## Development Review Division

### MEMORANDUM

**TO:** Ryan Amato, EVT Parker Colorado, LLC  
**FROM:** Ryan McGee, AICP, Associate Planner  
**DATE:** October 27, 2017  
**SUBJECT:** 1<sup>st</sup> submittal of Site Plan for Parker Auto Plaza Filing No. 1, Block 3, Lot 1 (Planning Case No. SP17-073).

SP17-073; Parker Auto Plaza Filing No. 1, Block 3, Lot 1

**PARKER & PINE**  
 PARKER, CO  
 CONSTRUCTION DOCUMENTS  
**SITE PLAN**

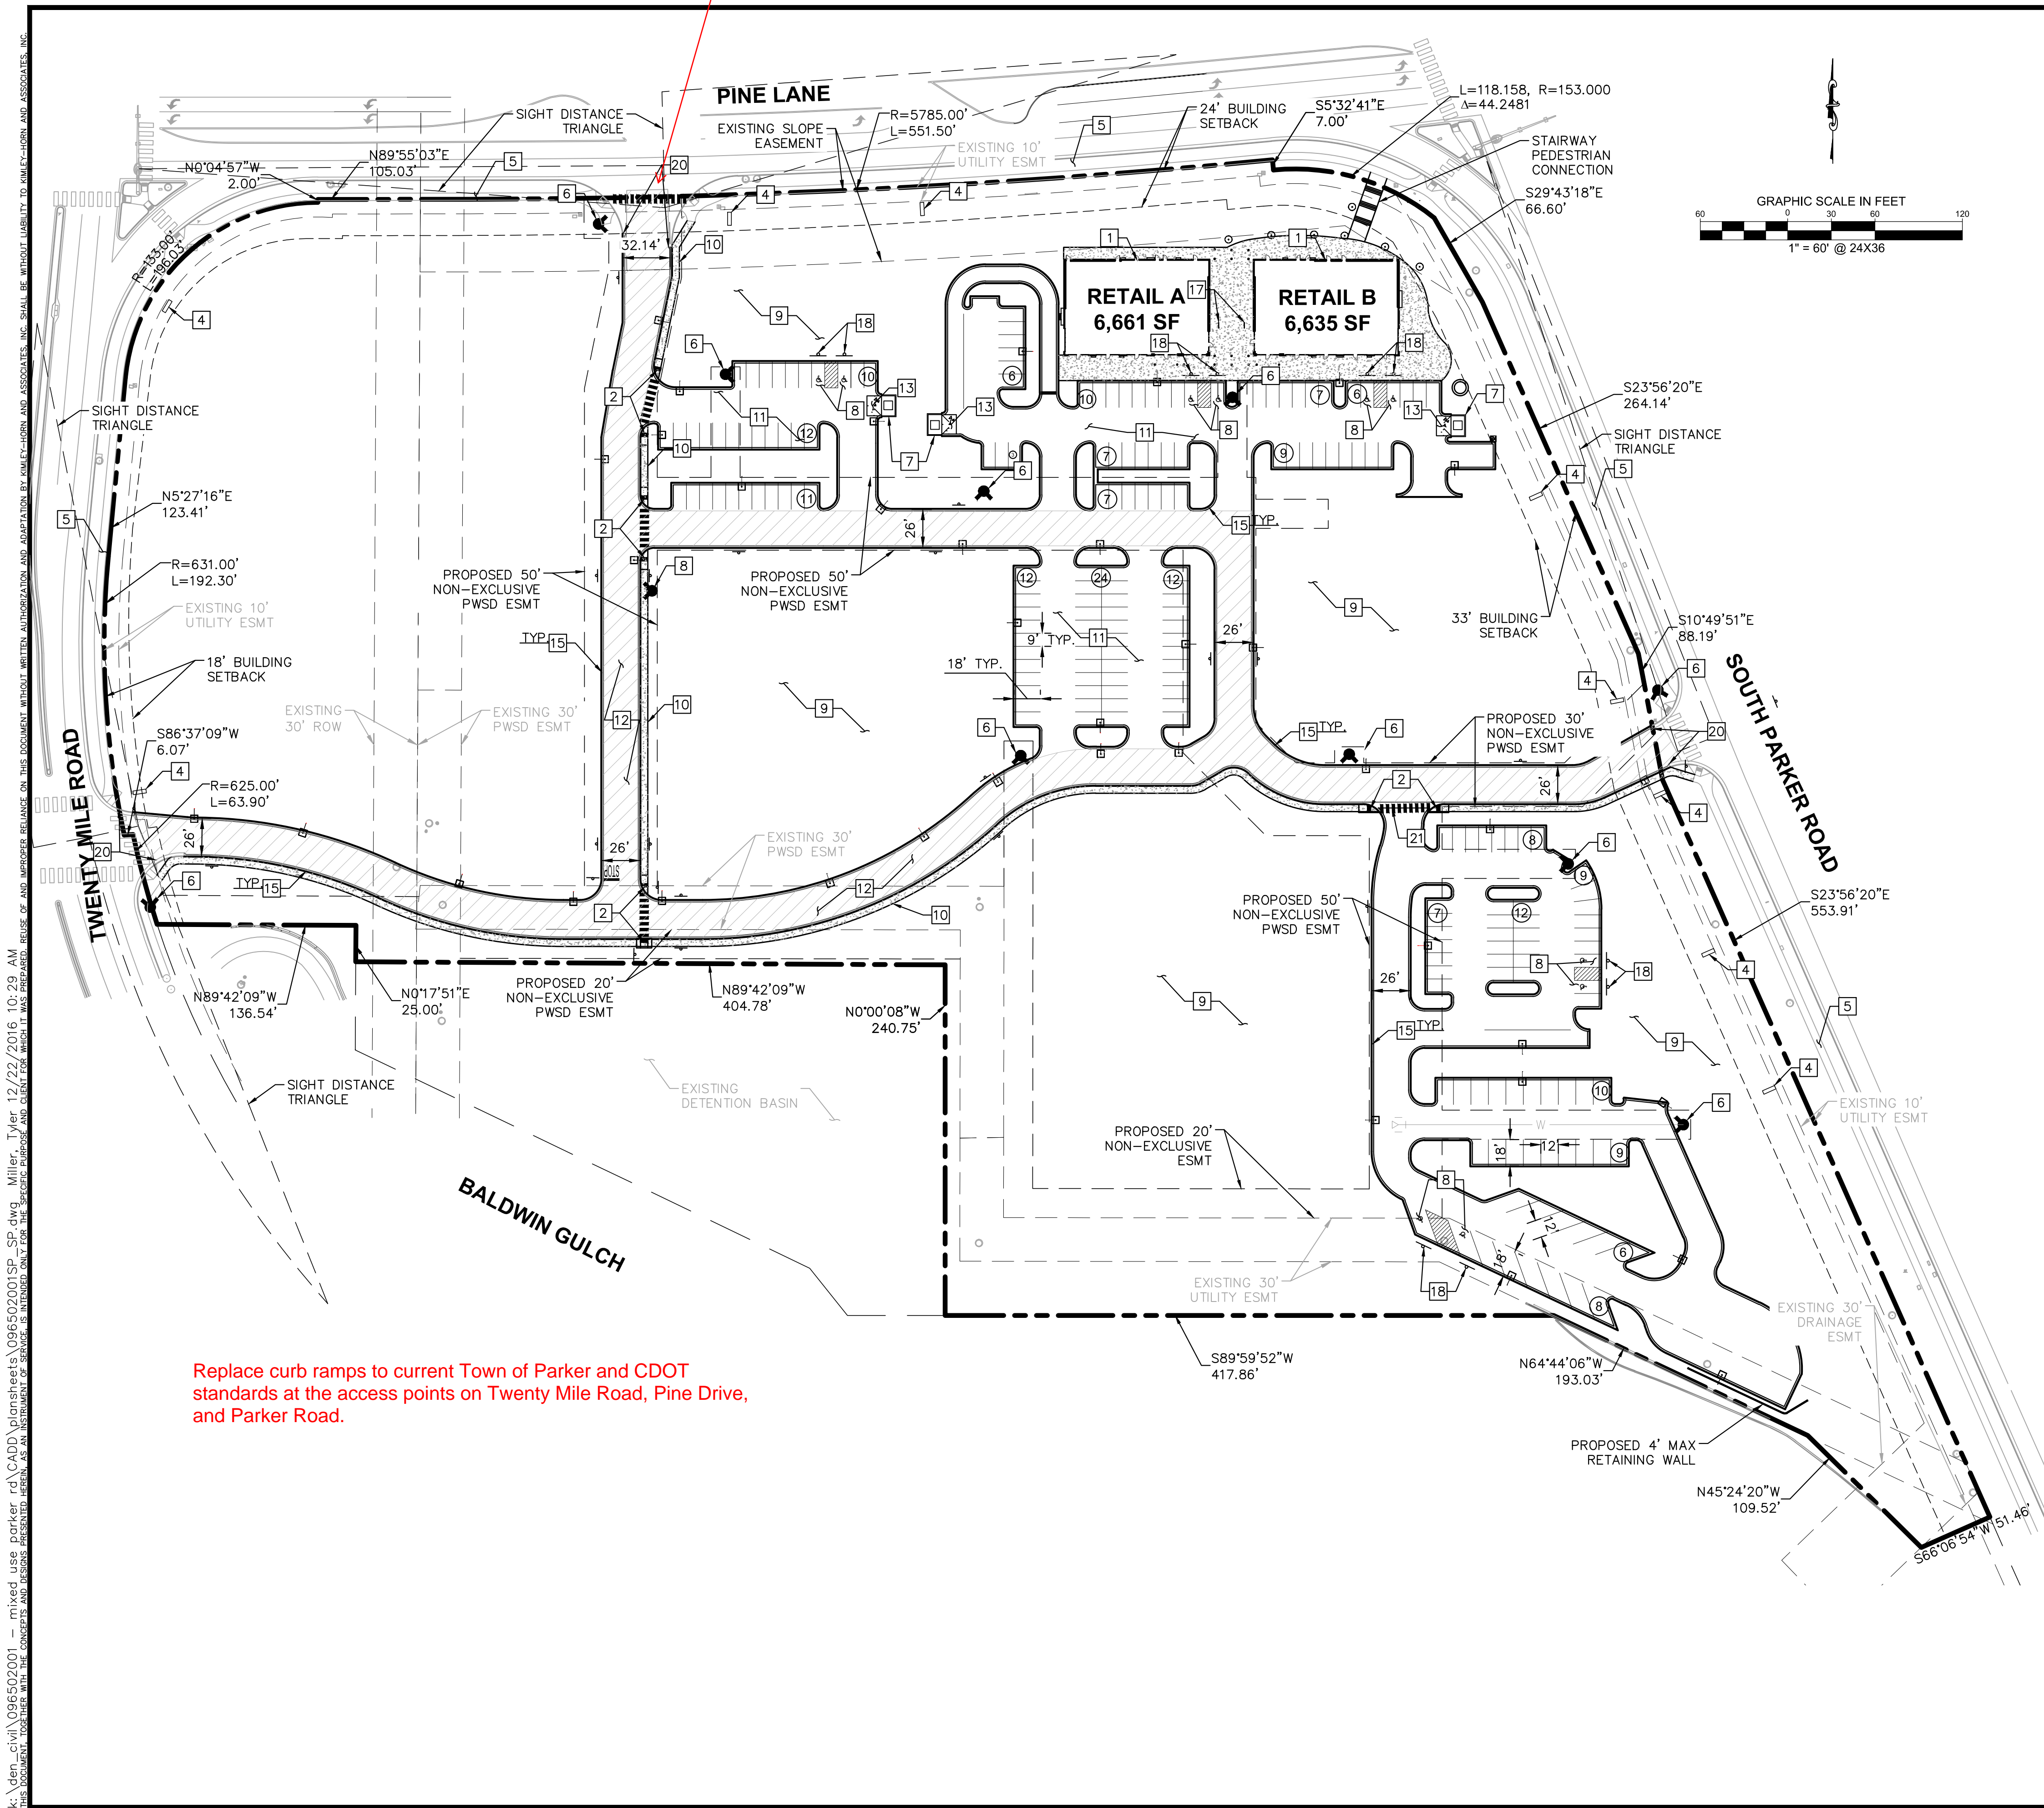
Per previous discussions with Town staff there will be no Left Turn allowed. Show striping, signage, and median limiting the turning movements.

Replace curb ramps to current Town of Parker and CDOT standards at the access points on Twenty Mile Road, Pine Drive, and Parker Road.

STORM LINE A PROFILE [STA 0+00 TO 5+00]

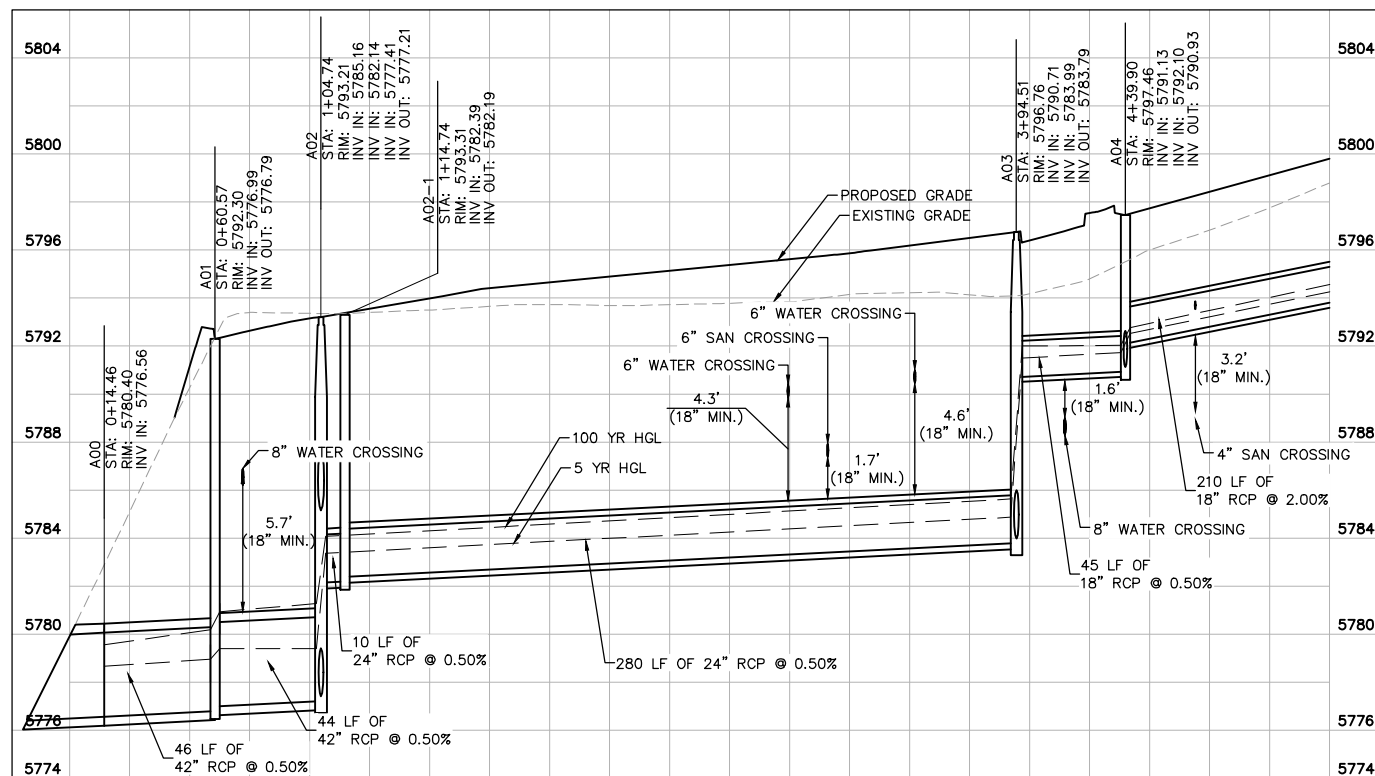
Label all manhole and inlet size and type consistent with the Drainage Report in both plan and profile.

PROJECT NO.  
096502001  
 DRAWING NAME  
096502001ST  
 C5.5

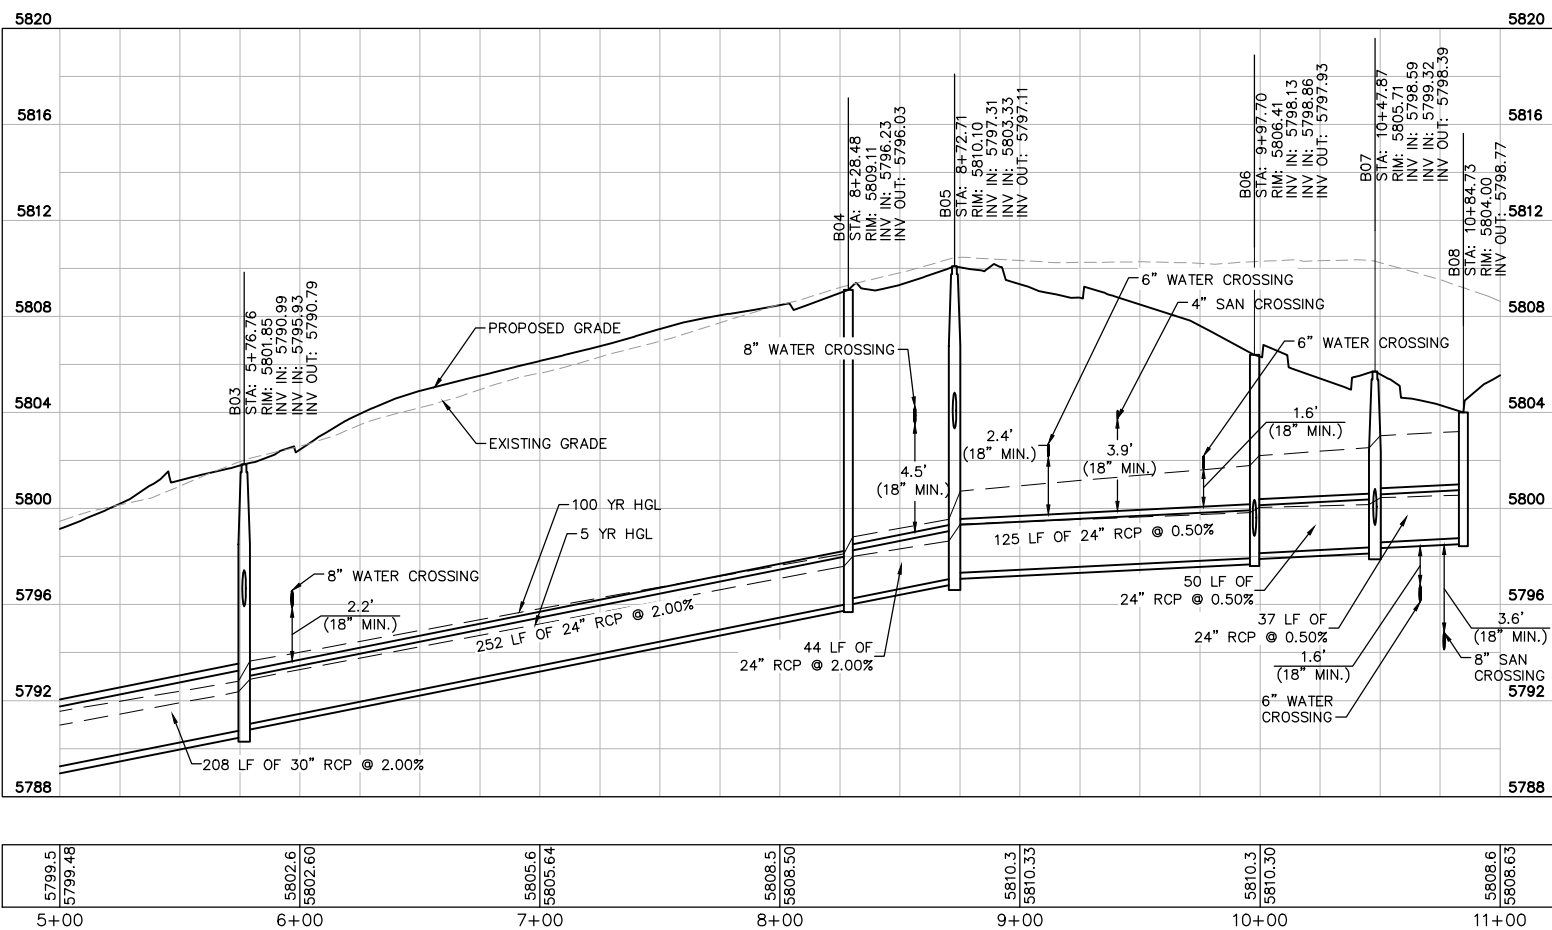
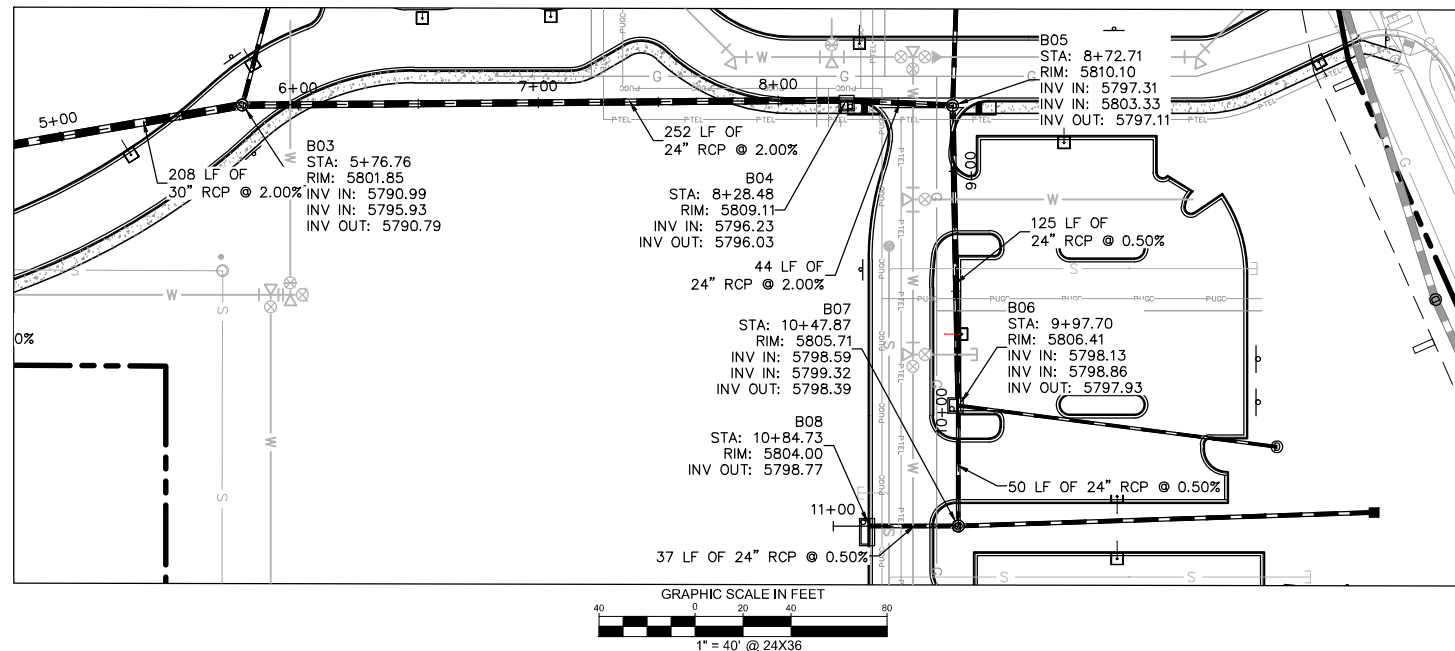
Label all manhole and inlet size and type consistent with the Drainage Report in both plan and profile.

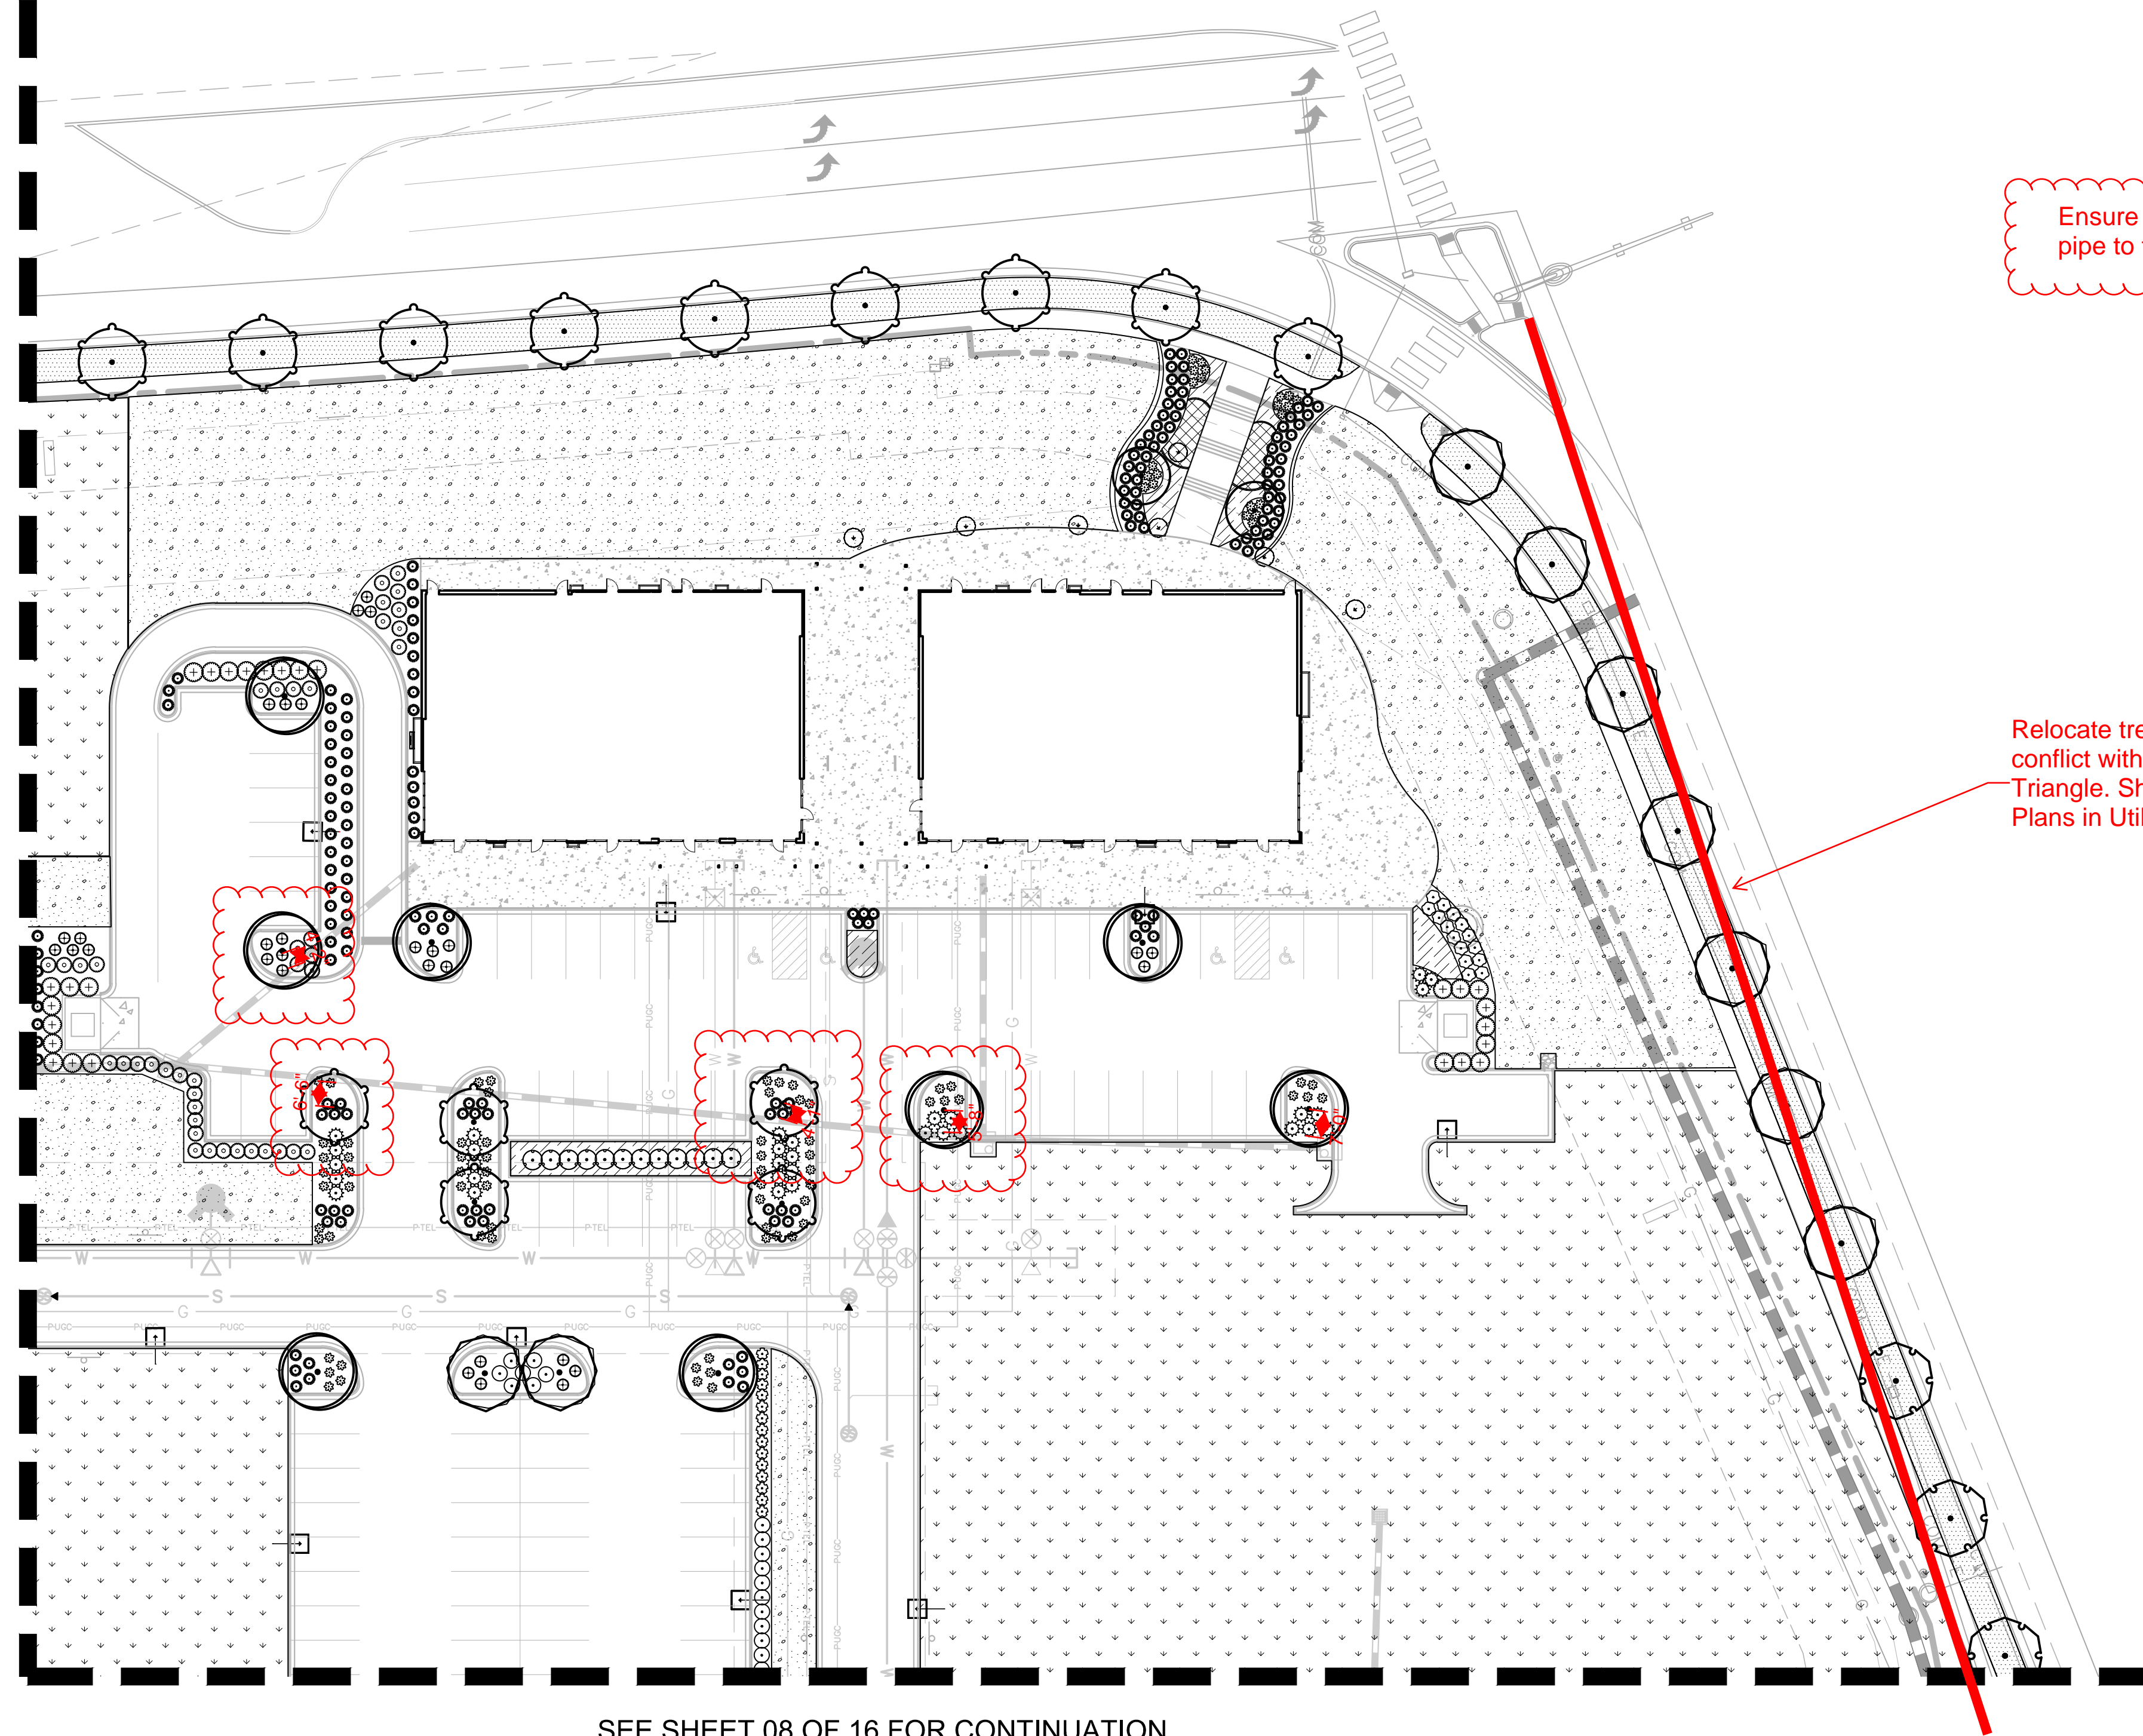
Ensure 10 feet separation from storm pipe to tree
